Public Input No. 158-NFPA 70-2023 [Definition: Ampacity.]

Committee: NEC-P06

Figure 5.2.1.1 – 14 AWG Copper NM-B at 15-amps in R-21 Insulation

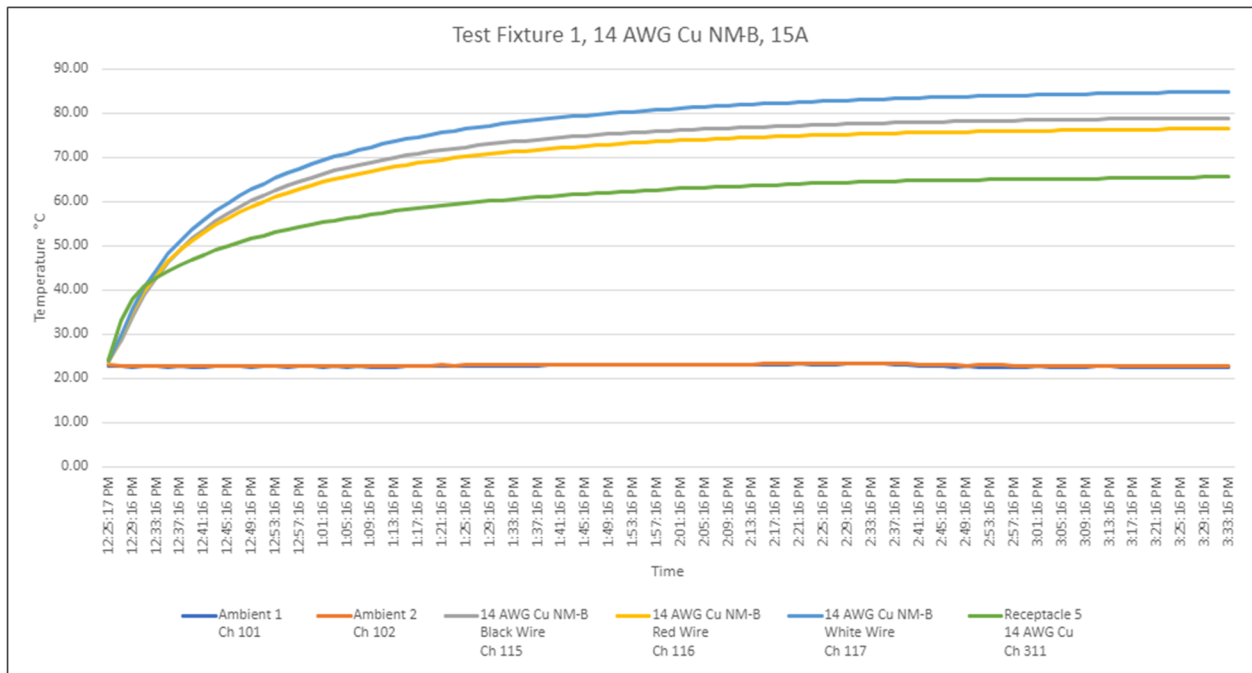
The testing data indicates that at temperature equilibrium the highest temperature for 14 AWG copper NM-B cable, at 15 amps, installed in R-21 fiberglass batt insulation, to be 85.06°C or 62.35°C temperature rise above ambient. See figure 5.2.1.1 below.

Figure 5.2.1.2 – 14 AWG CCA NM-B at 10-amps in R-21 Insulation

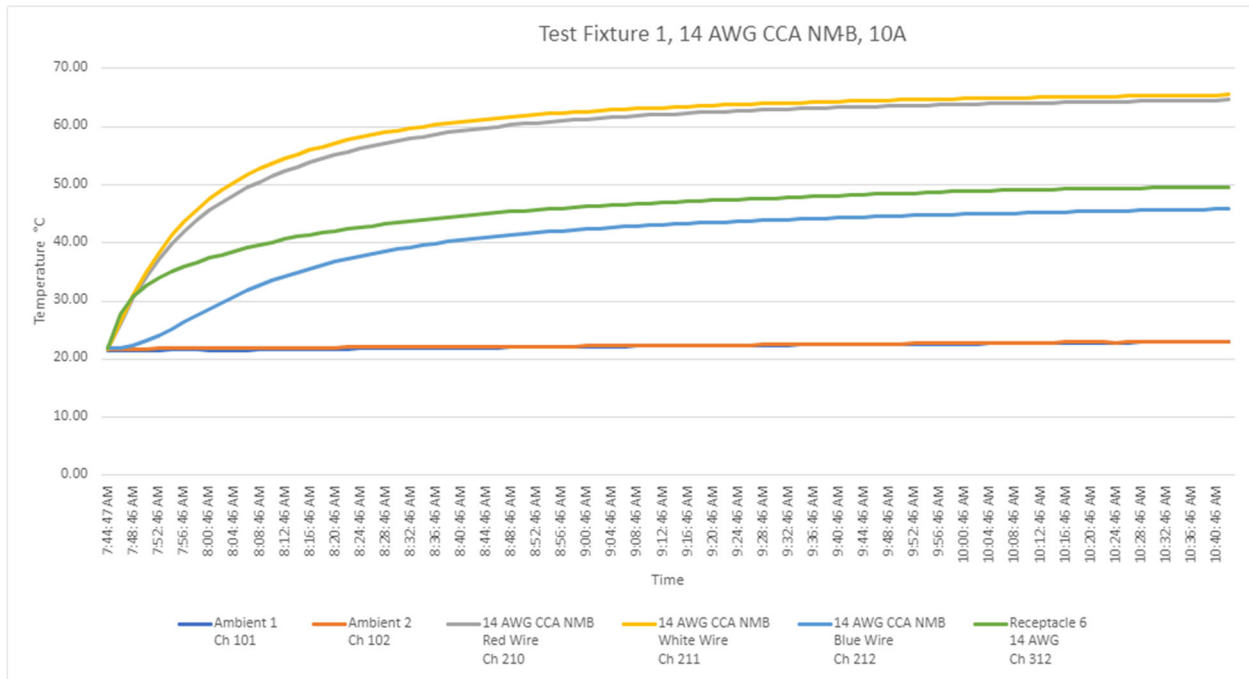
The testing data in the same configuration indicates the highest temperature for the 14 AWG copper-clad aluminum NM-B cable, at 10 amps, to be 65.48°C or 42.51°C temperature rise above ambient. See figure 5.2.1.2 below. Neither of these cable assemblies attained the 90°C temperature rating of the internal THHN conductors.

The CCA application is operating at a temperature of 19.58°C, or 23 percent, less than the steady state 14 AWG copper NM-B cable.

Figure 5.2.2.1 – 14 AWG Copper NM-B at 15-amperes in R-30 Insulation

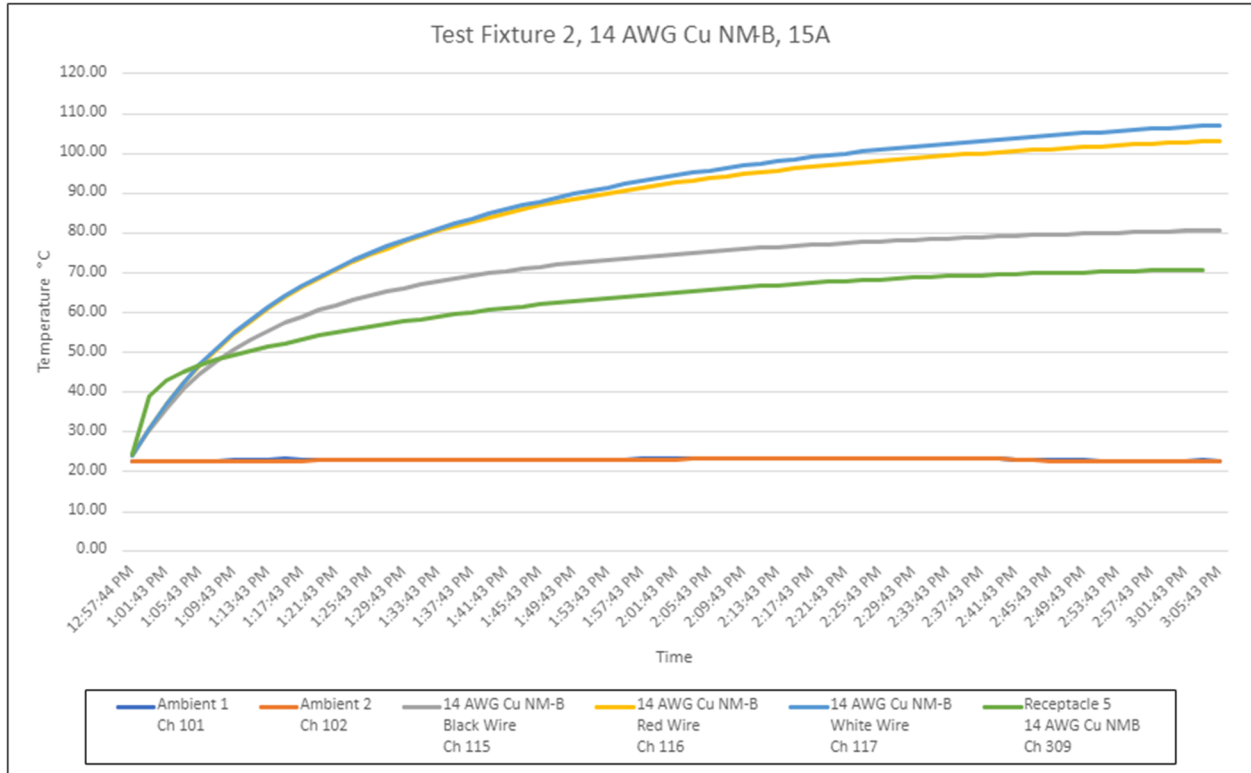
The testing data indicates the highest temperature for 14 AWG copper NM-B cable, at 15 amps, installed in R-30 spray foam insulation, to be 107.08°C or 84.1°C temperature rise above ambient. The final temperature was not at equilibrium and was continuing to slowly rise when the testing was terminated. See figure 5.2.2.1 below.

Figure 5.2.2.2 – 14 AWG CCA NM-B at 10-amperes in R-30 Insulation

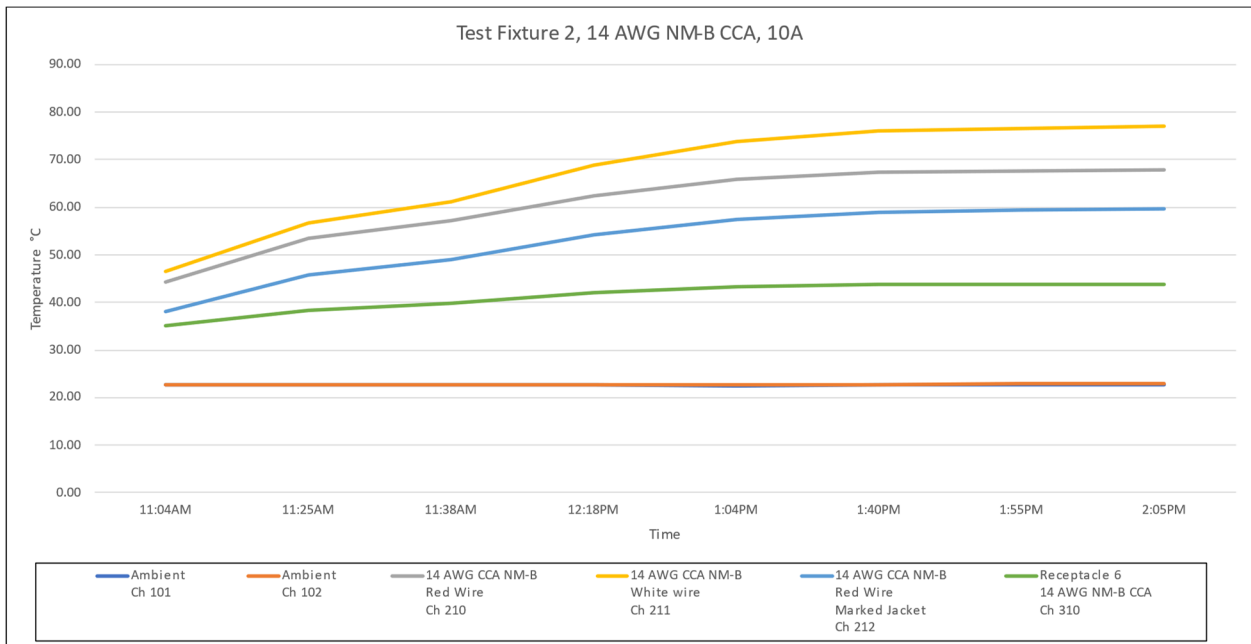
The testing data in the same configuration indicates the temperature at temperature equilibrium for the 14 AWG copper-clad aluminum NM-B cable, at 10 amps, to be 77.0°C or 54.29°C temperature rise above ambient. See figure 5.2.2.2 below. While the 14-3 NM-B copper conductors exceeded the 90°C insulation rating of the internal conductors, the 14-3 NM-B CCA conductors did not.

The CCA application is operating at a temperature of 30.08°C, or 28.1 percent, less than the 14 AWG copper NM-B cable.

Figure 5.2.3.1 – 14 AWG Copper NM-B at 15-amps in R-60 Insulation

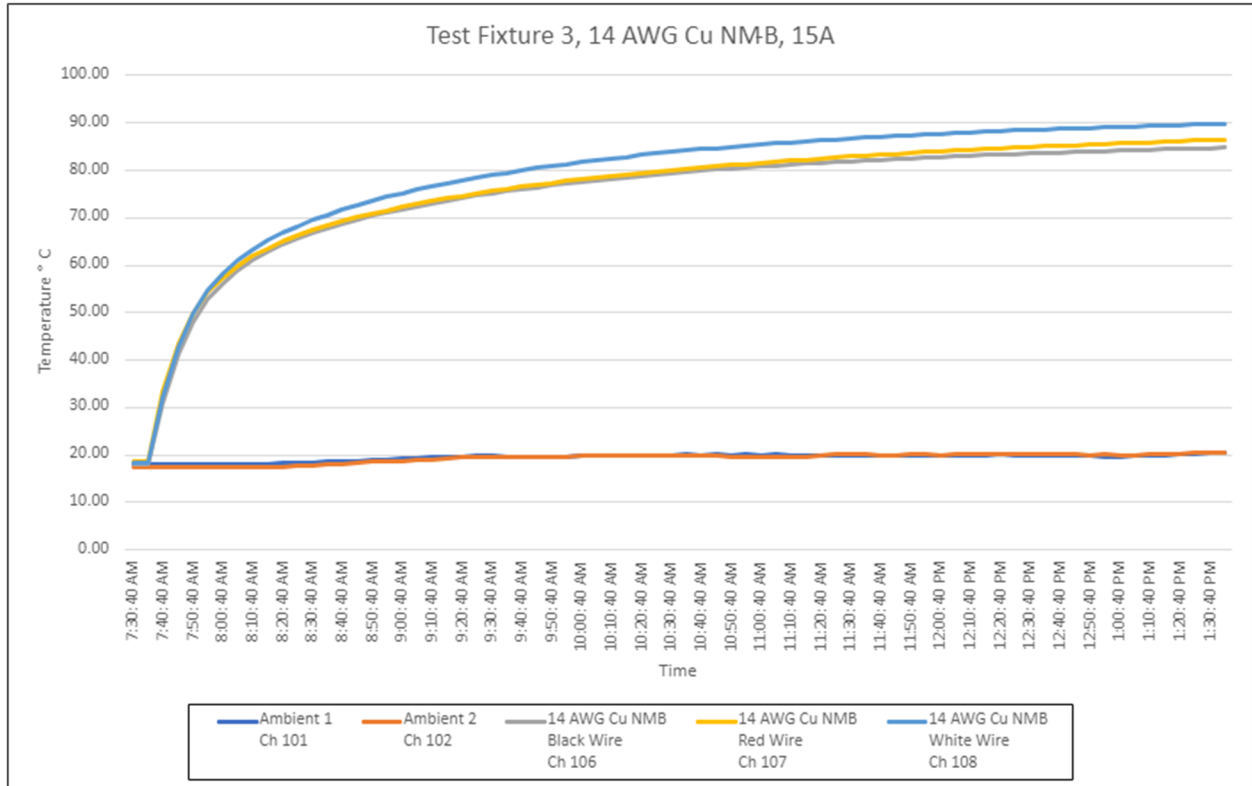
The testing data indicates that at temperature equilibrium the highest temperature for 14 AWG copper NM-B cable, at 15 amps, installed in R-60 blown in insulation, to be 89.81°C or 69.41°C temperature rise above ambient. See figure 5.2.3.1 below.

Figure 5.2.3.2 – 14 AWG CCA NM-B at 10-amps in R-60 Insulation

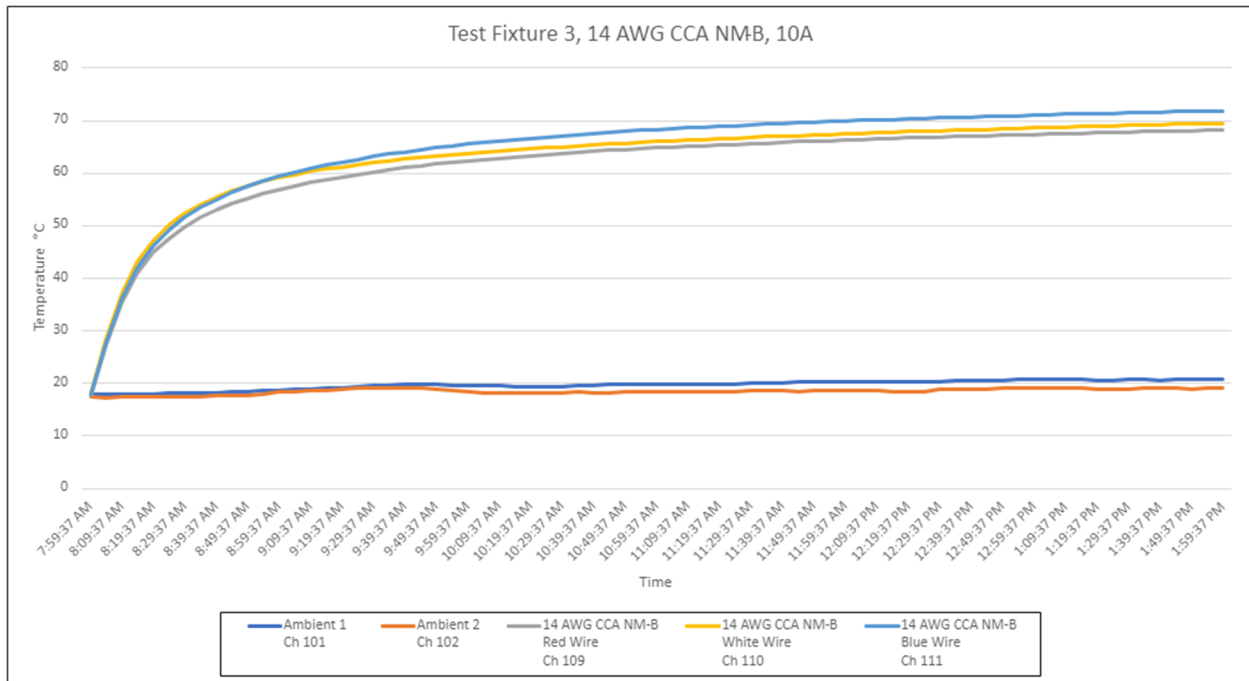
The testing data in the same configuration indicates the highest temperature for the 14 AWG copper-clad aluminum NM-B cable, at 10 amps, to be 71.9°C or 52.87°C temperature rise above ambient. See figure 5.2.3.2 below. Although the copper was close, neither of these cable assemblies attained the 90°C temperature rating of the internal THHN conductors.

The CCA application is operating at a temperature of 17.91°C, or 19.9 percent, less than the steady state 14 AWG copper NM-B cable.

Figure 5.3.1.1 – 14 AWG Copper THHN at 15-amps in R-21 Insulation

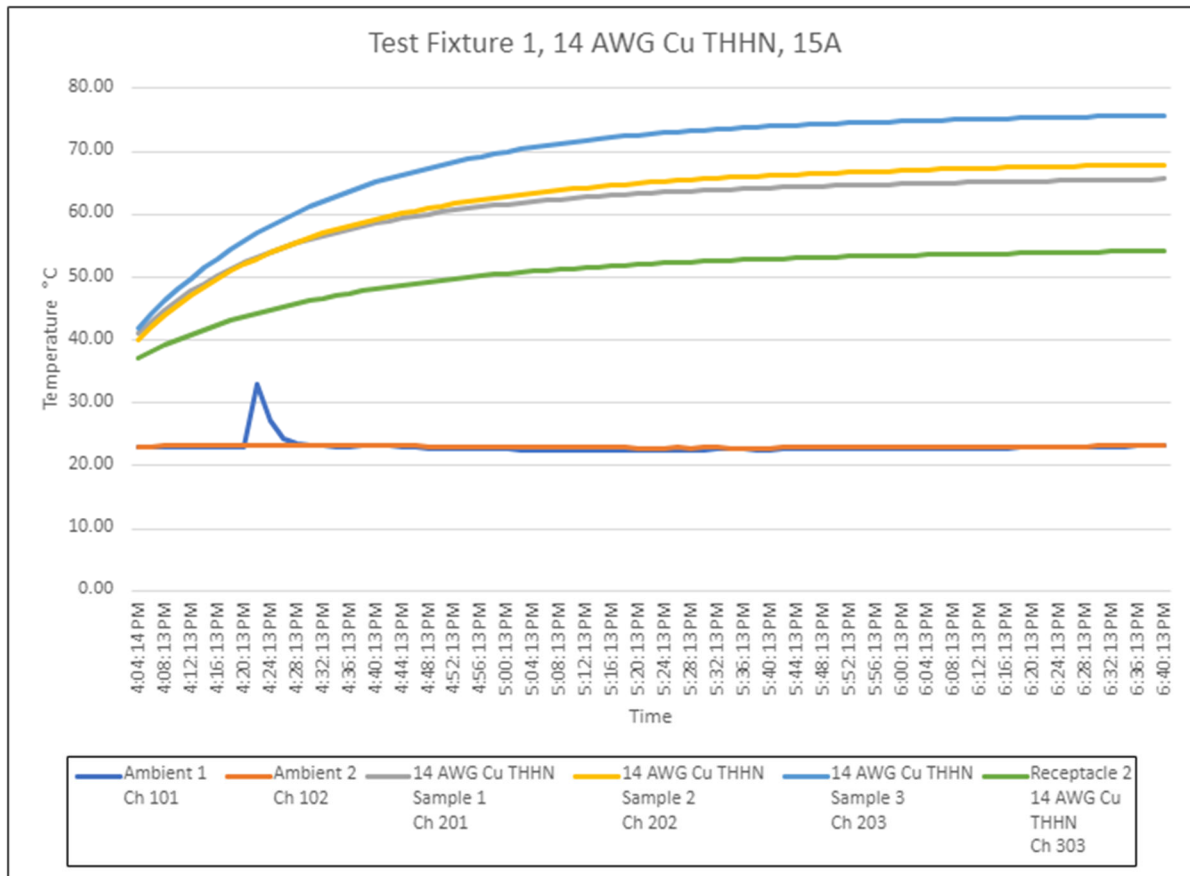
The testing data indicates that at temperature equilibrium the highest temperature for 14 AWG copper THHN installed in ENT, at 15 amps, installed in R-21 fiberglass batt insulation, to be 75.76°C or 52.57°C temperature rise above ambient. See figure 5.3.1.1 below.

Figure 5.3.1.2 – 14 AWG CCA THHN at 10-amps in R-21 Insulation

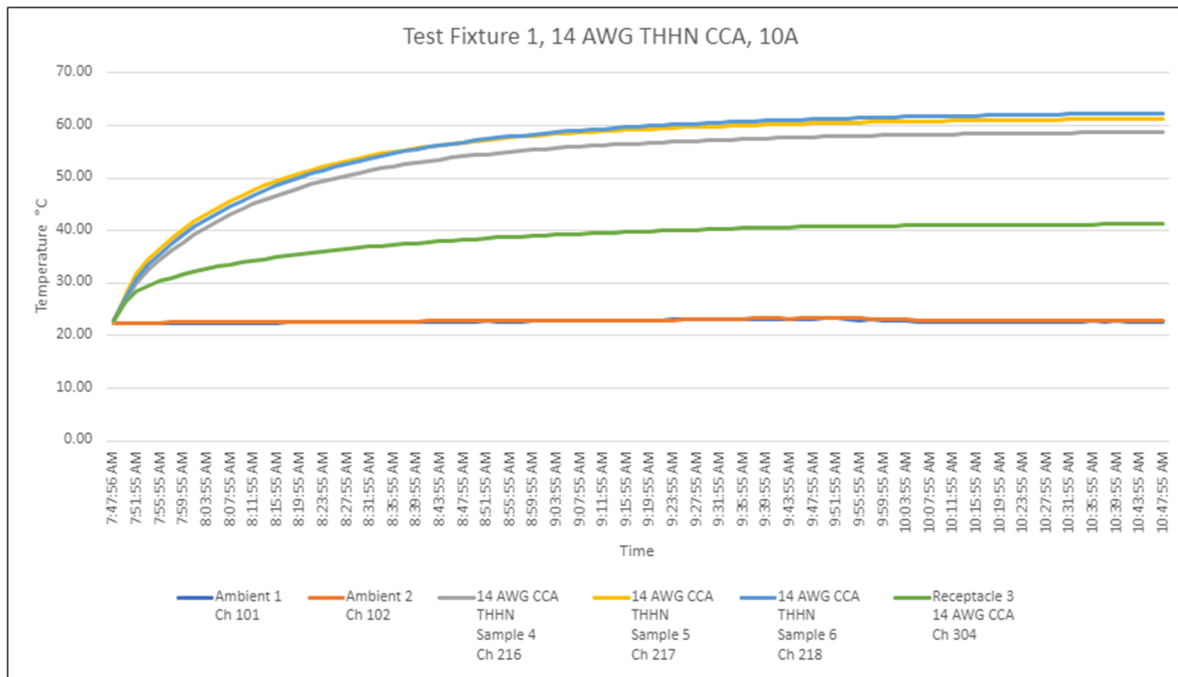
The testing data in the same configuration indicates the highest temperature for the 14 AWG CCA THHN installed in (ENT), at 10 amps, to be 62.35 or 39.64°C temperature rise above ambient. See figure 5.3.1.2 below. Neither of these cable assemblies attained the 90°C temperature rating of the THHN conductors.

The CCA application is operating at a temperature of 13.41°C, or 17.7 percent, less than the steady state 14 AWG copper THHN conductors.
